Bid Bulletin #04

PROJECT: Weeping Water Public Schools
Additions & Renovations
Weeping Water, NE

RE: Addendum No. 3 to the Bidding Documents for:
Weeping Water Public Schools
Additions & Renovation
204 West O Street
Weeping Water, Nebraska 68463
Schemmer Project No. 06368.001

SHEET NO: SDA-11

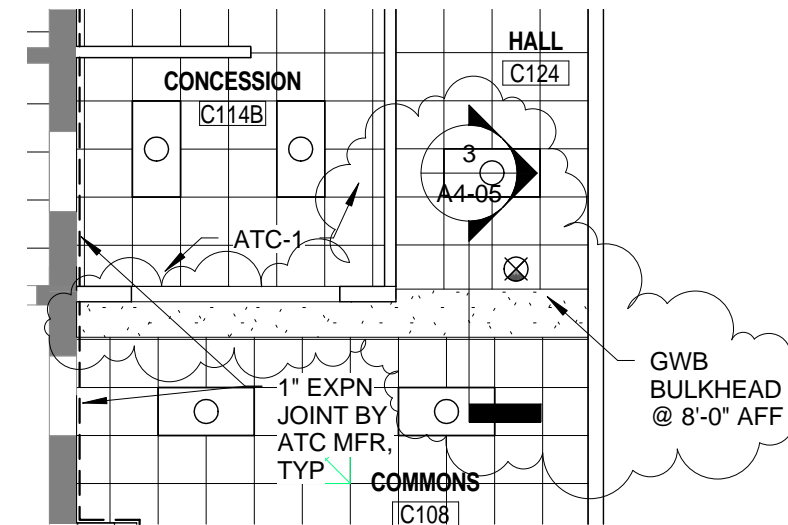
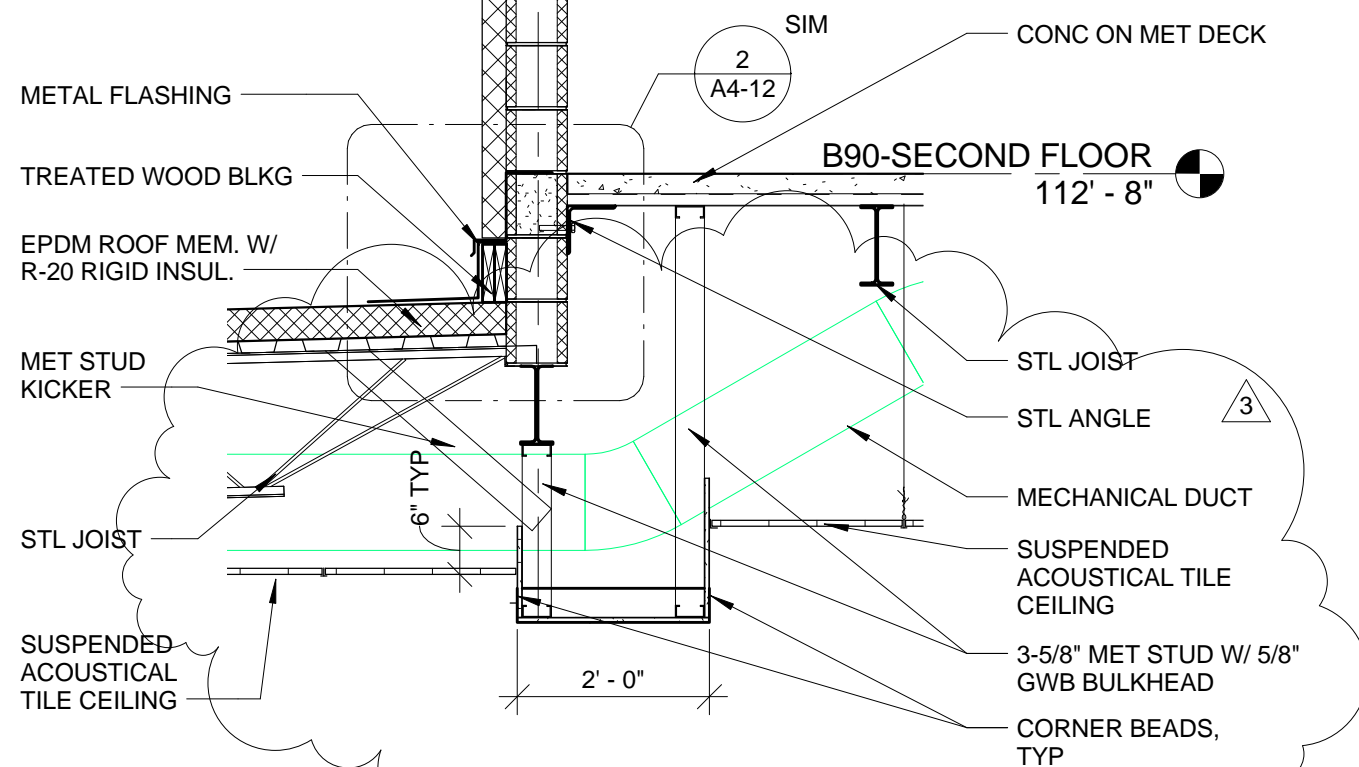
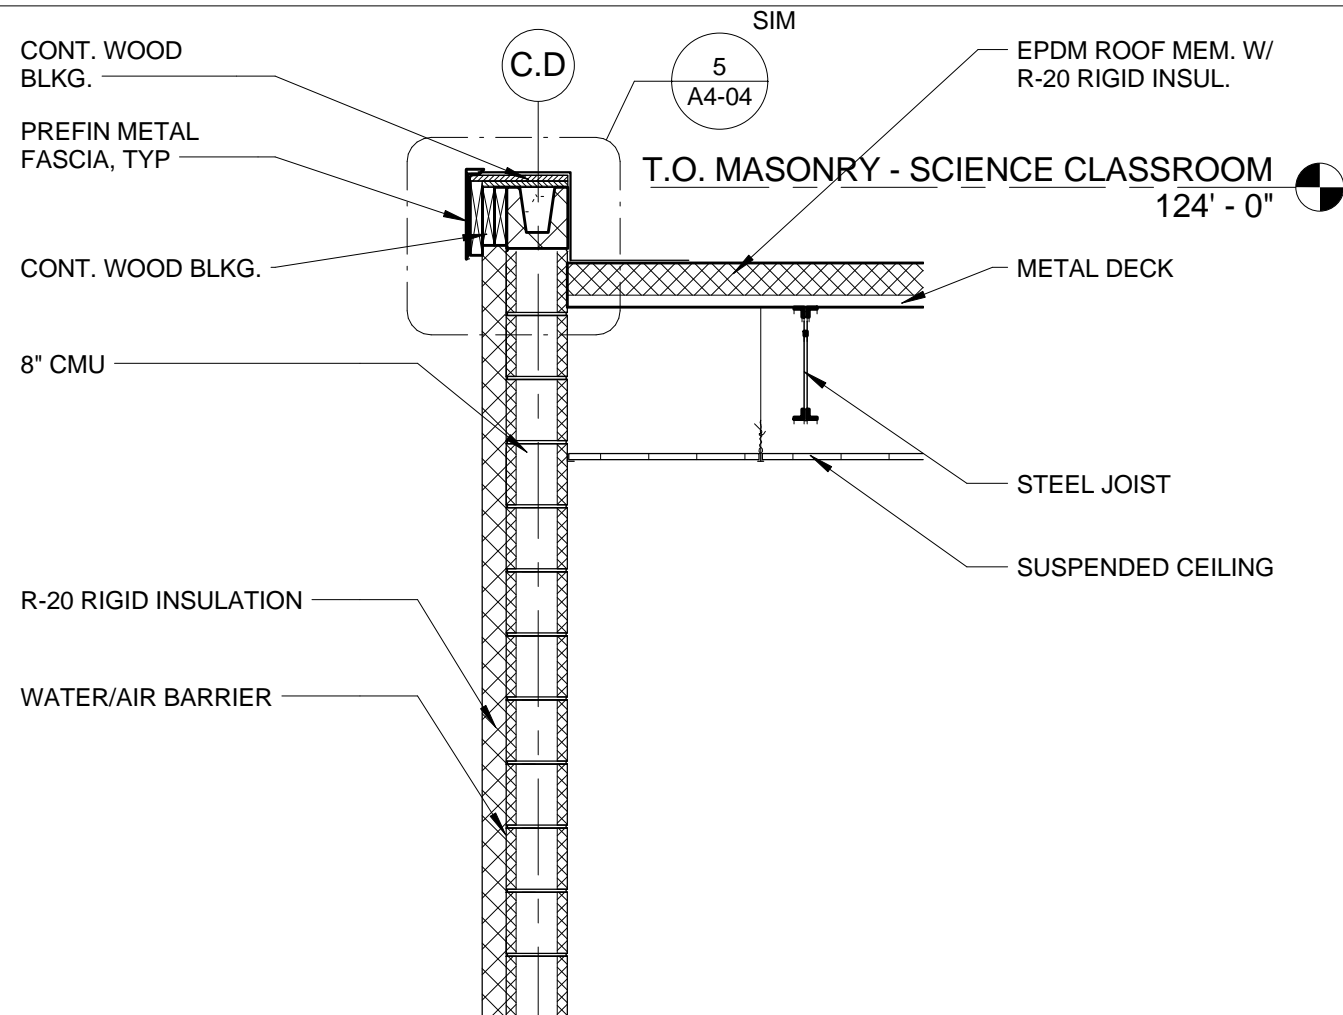
- 1) Wall Section 3
 - a. See SDA-11 for revisions.

- 1) FIRST FLOOR PLAN – AREA C – REFLECTED CEILING
 - a. See SDA-11 for revisions.

SHEET NO: SDA-12

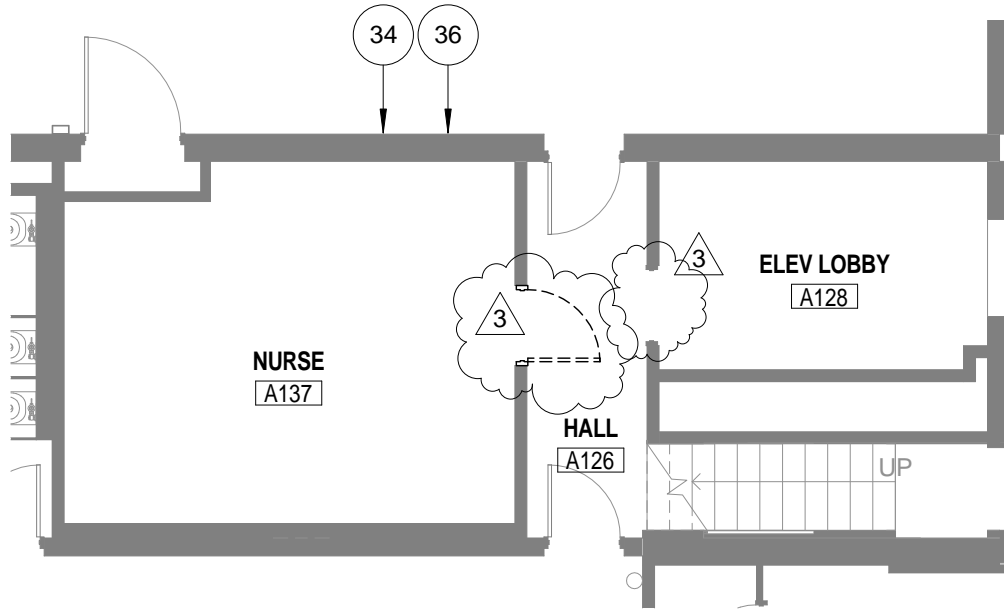
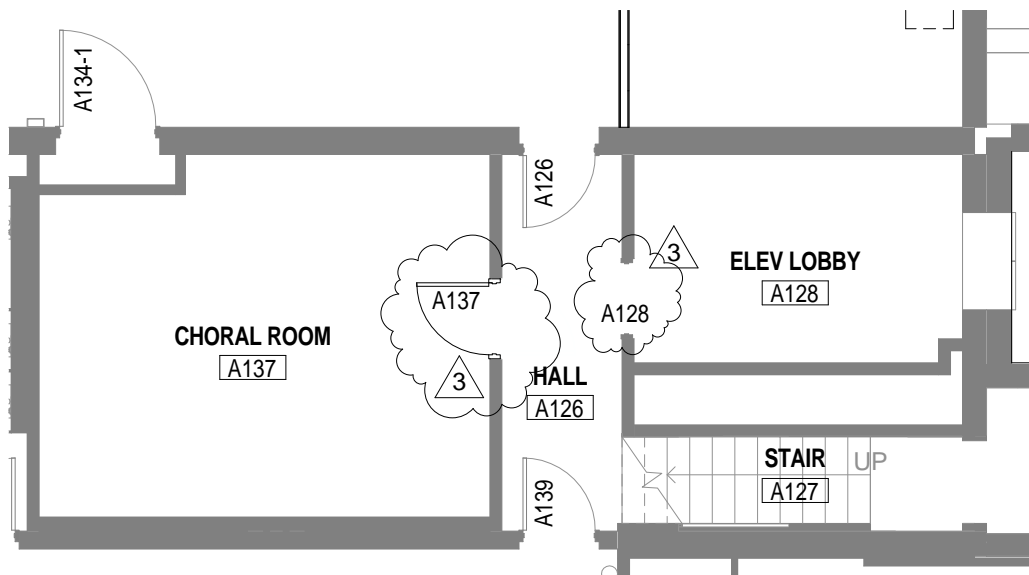
- 2) Remove existing door and frame into NURSE A137. Salvage for relocation. (SEE SDA-12 attached.)
- 3) Remove existing door swing @ ELEV LOBBY A128. No existing door at this location. (see SDA-12 attached.)

- 1) Reinstall door and frame A137 as shown on SDA-12 attached.

SHEET NO: SDA-13

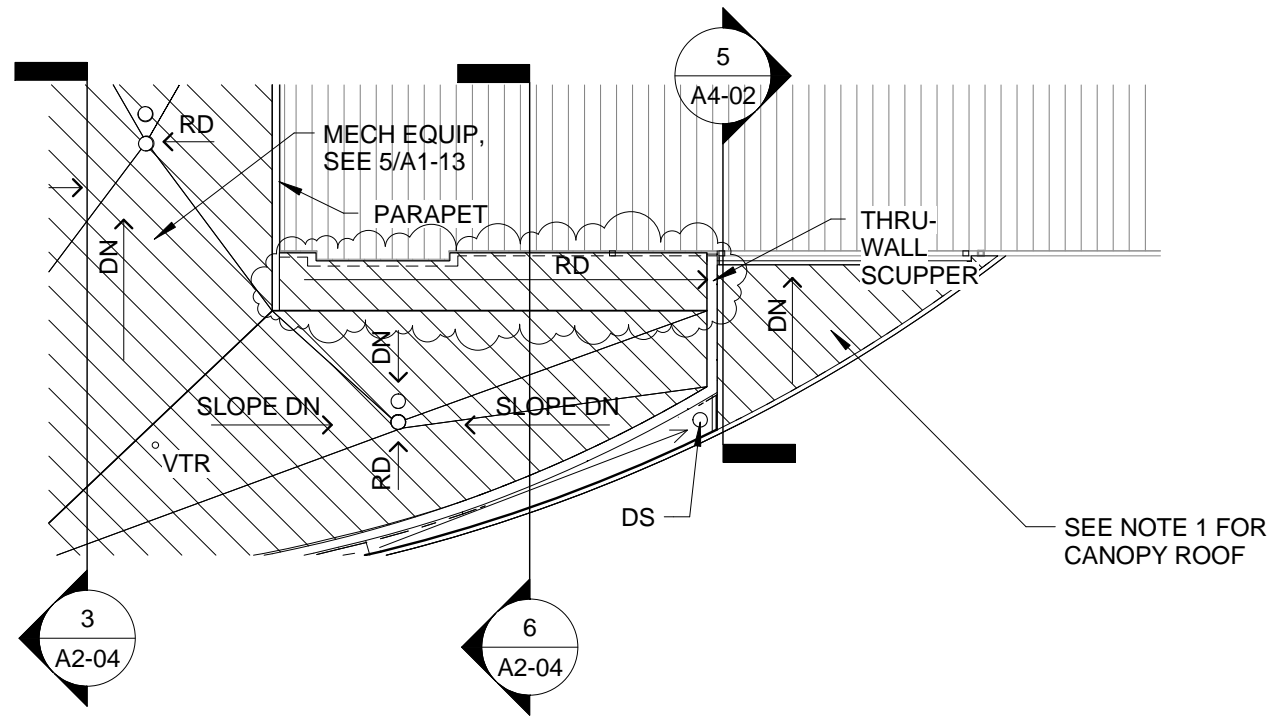
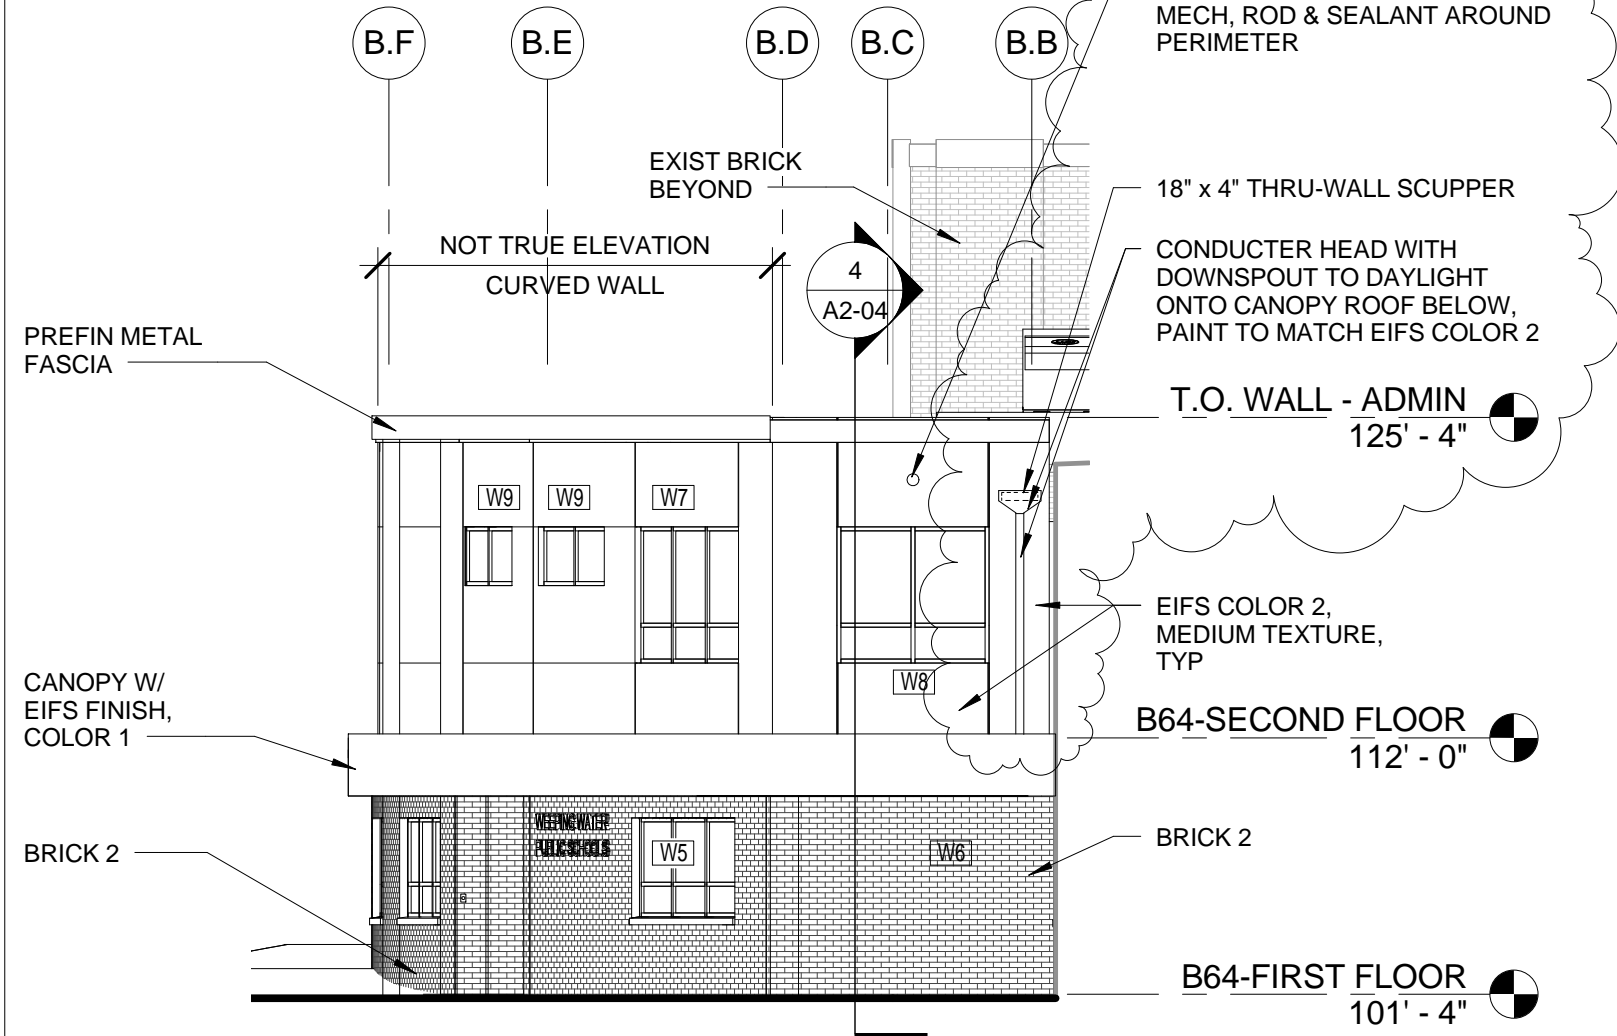
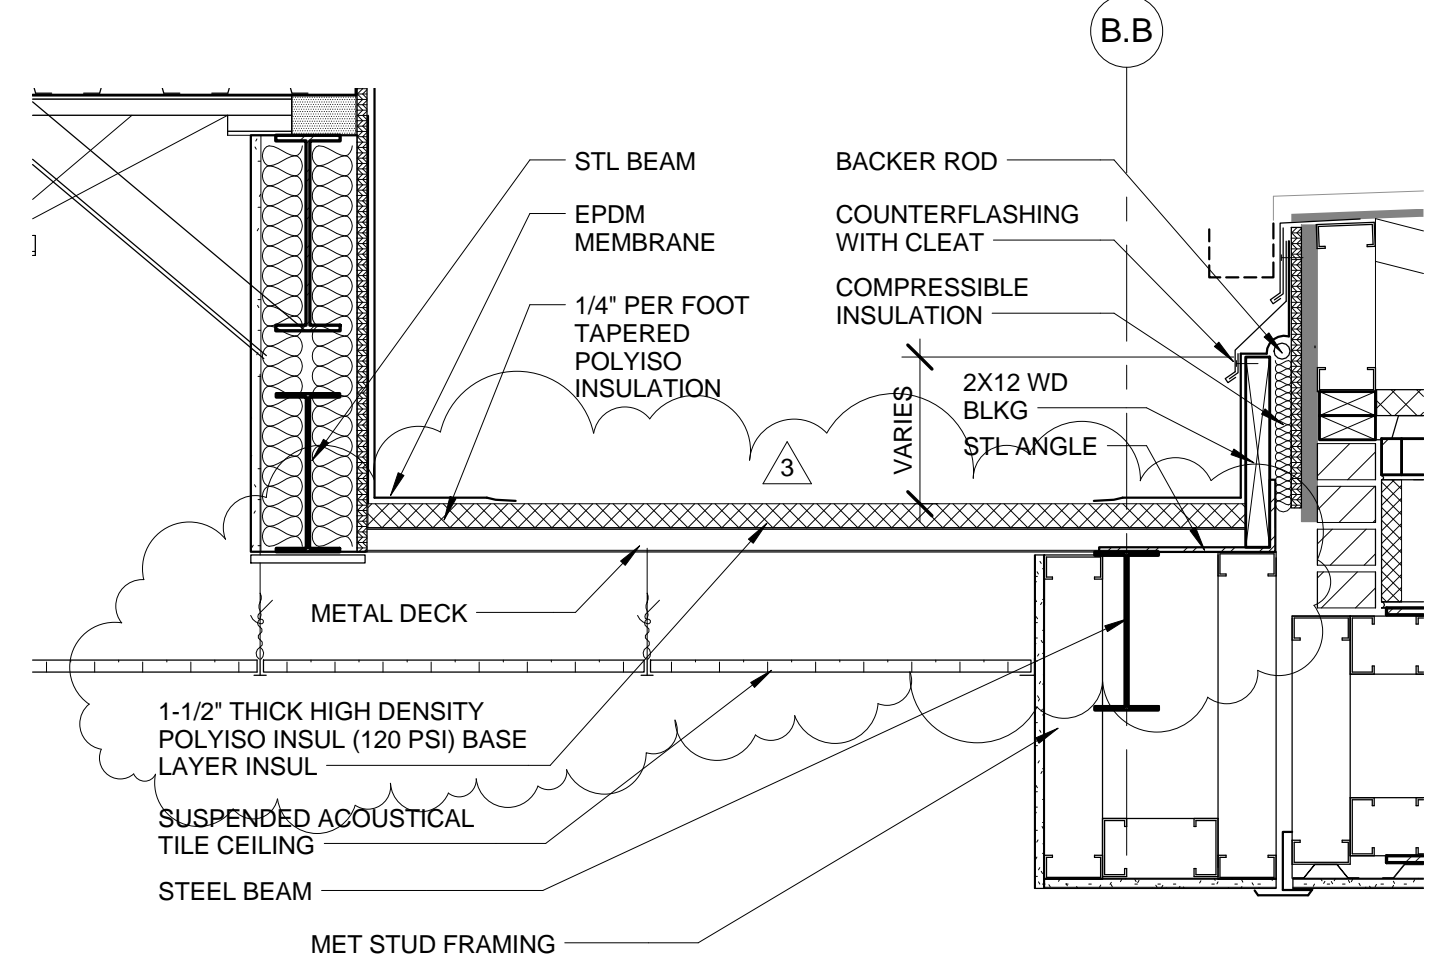
- 1) Roof Plan
 - a. See attached SDA-13 for revisions.

- 1) 2/Enlarged East Elevation @ Admin / Library Addition
 - a. See attached SDA-13 for revisions.

- 1) Detail 6
 - a. See attached SDA-13 for revisions.

SHEET NO: SDS-7

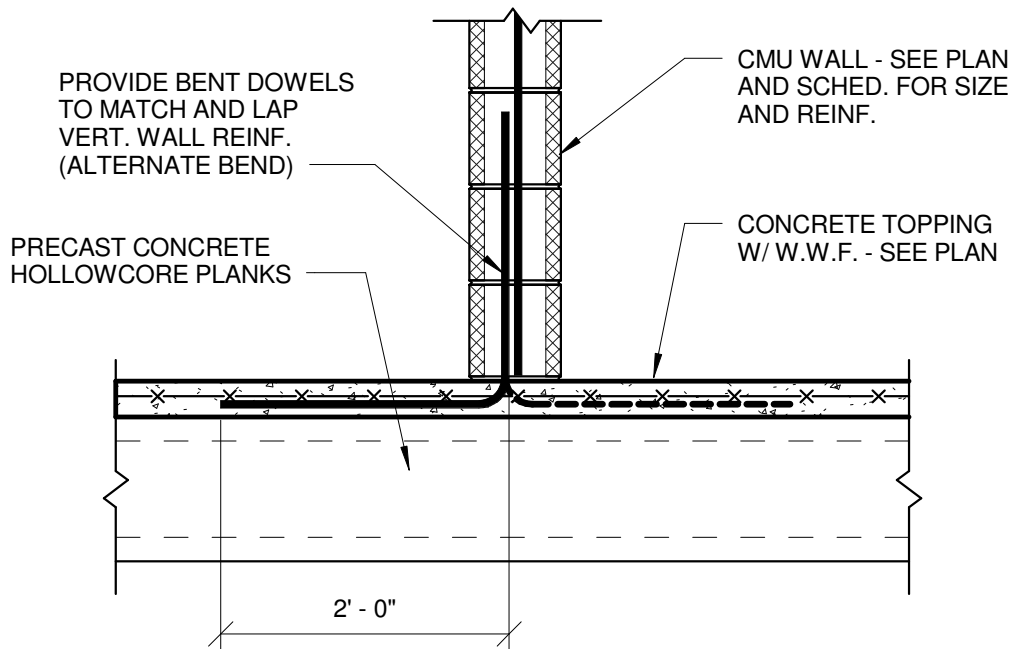
- 1) Detail 6/S3-05, ADD note "REFER TO DETAIL 5/S3-08 FOR AN ALTERNATE METHOD OF ANCHORING CMU WALLS ABOVE PRECAST HOLLOWCORE PLANKS".

- 1) ADD detail 5/S3-08 as shown on attached supplemental drawing SDS-7.

THIS DETAIL IS AN ALTERNATE METHOD OF ANCHORING CMU WALLS ABOVE PRECAST HOLLOWCORE PLANKS (SEE DETAIL 6/S3-05).

SHEET NO: SDF-1

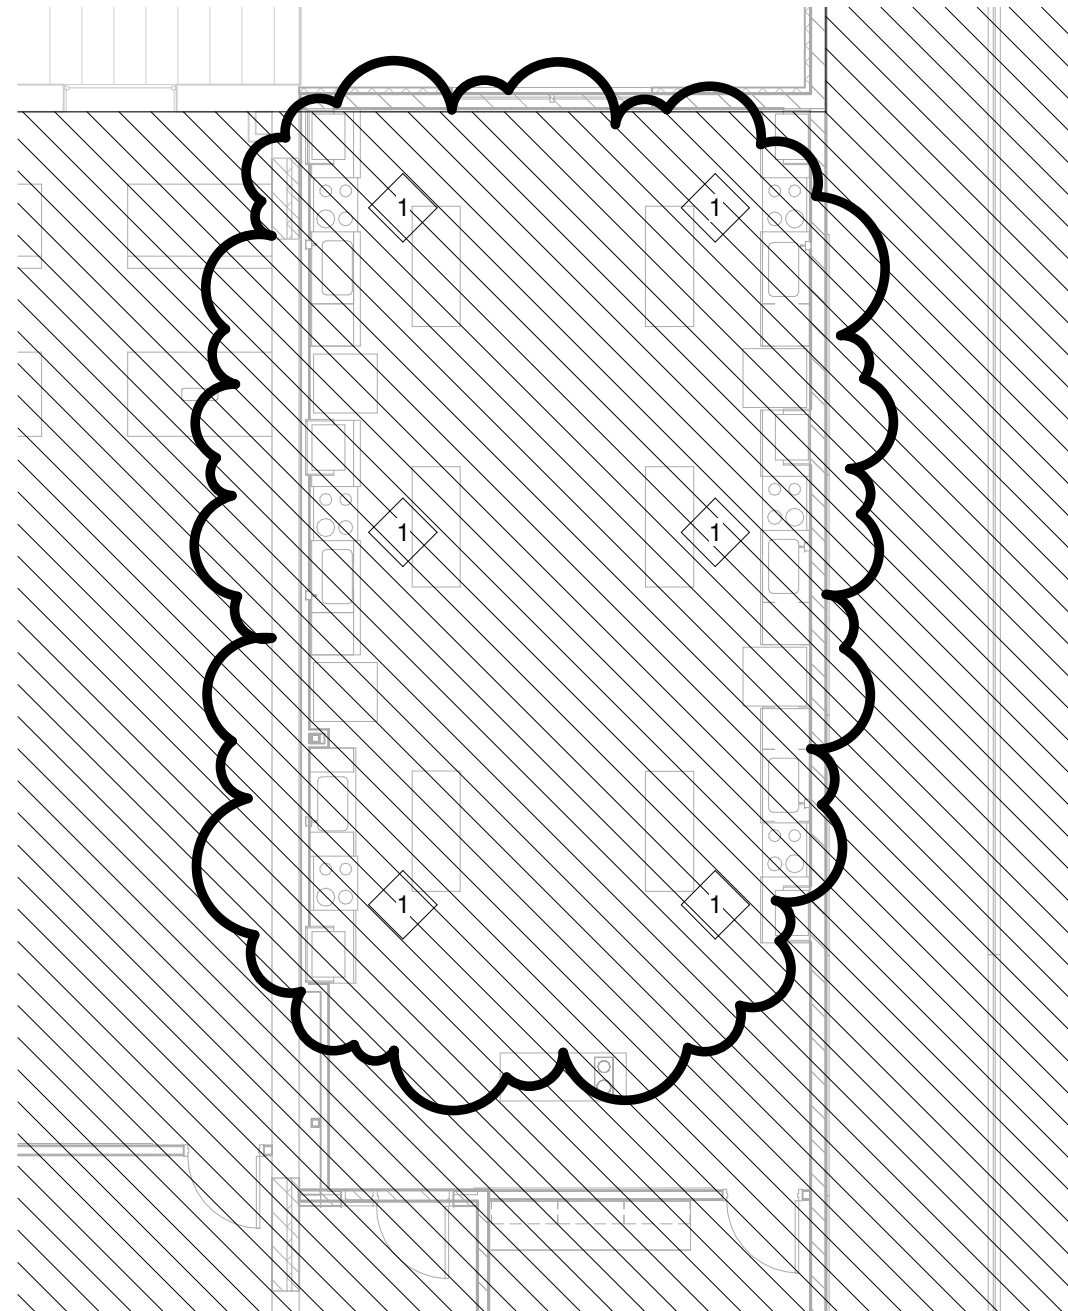
- 1) Add sprinkler protection to eyebrow hoods over cooktops in Consumer Science room; see supplemental drawing SDF-1.

1. PROVIDE HIGH-TEMPERATURE SPRINKLERS IN EXHAUST HOODS OVER COOKING RANGE AND PORTABLE FIRE EXTINGUISHERS IN ACCORDANCE WITH NFPA 96, NFPA 13, AND LIFE SAFETY CODE 101.
